PoE Plus
IEEE 802.3at
Classification Ad Hoc
Extended Classification Using
Two Classification Events

Clay Stanford
Linear Technology

January 10, 2007
Ad Hoc Meeting

802.3at Classification Using Two Classification Events

Classification State Engine in PD

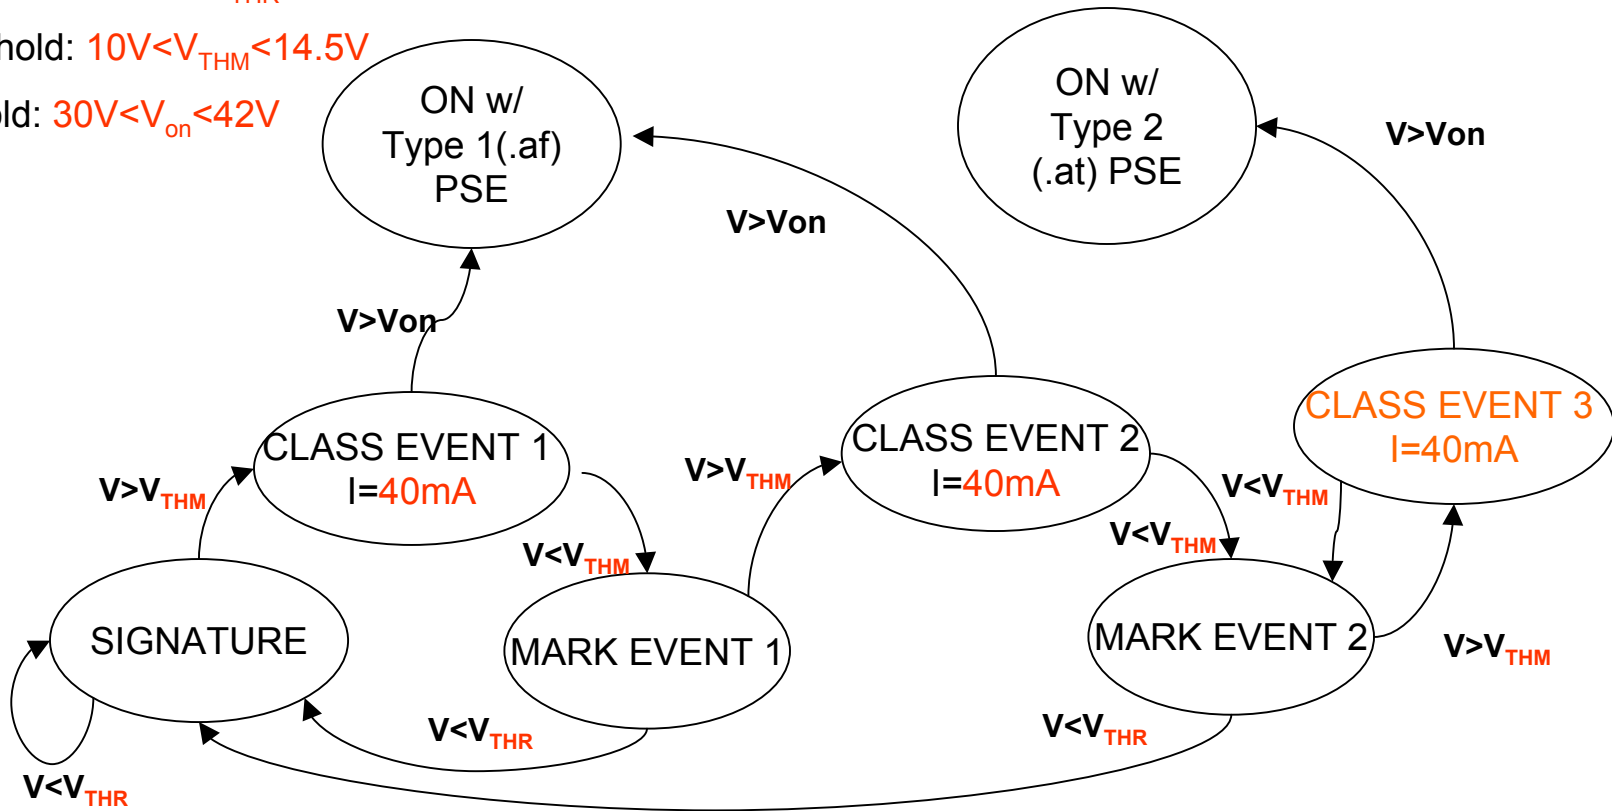
- Reset Threshold: $2.8V \leq V_{THR} < 6.9V$
- Mark Threshold: $10V < V_{THM} < 14.5V$
- On Threshold: $30V < V_{on} < 42V$

Class Event 3 exists to create a defined behavior for Type 2(.at) PDs when pinged repeatedly. This allows future expansion of the classification mechanism with a known response from Type 2(.at) PDs.

PD Behavior During Mark Event

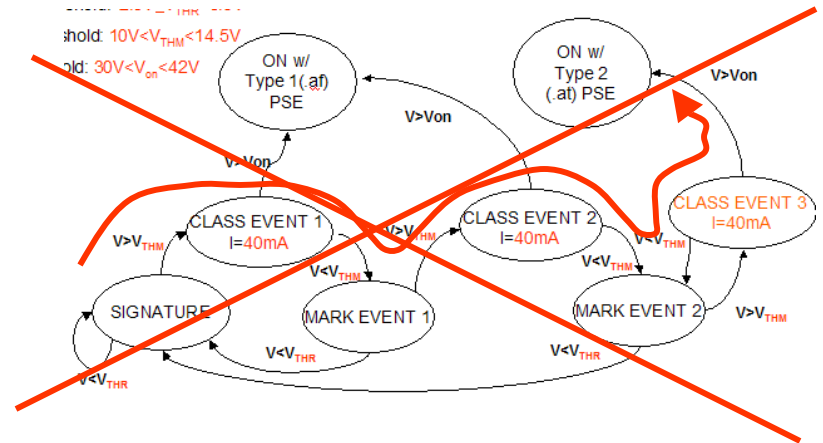
- ~~PD not to present 25Kohm during mark to address non-compliant PSE~~
- Range of PD current limited to ease PSE design task

PD MARK MODE SPECIFICATION

- ~~PD 2-point signature to be:~~
 ~~$R_{PD} < 15Kohm$ or $R_{PD} > 33Kohm$~~
- PD current to be:
 $0.25mA < I_{PD} < 2.0 mA$
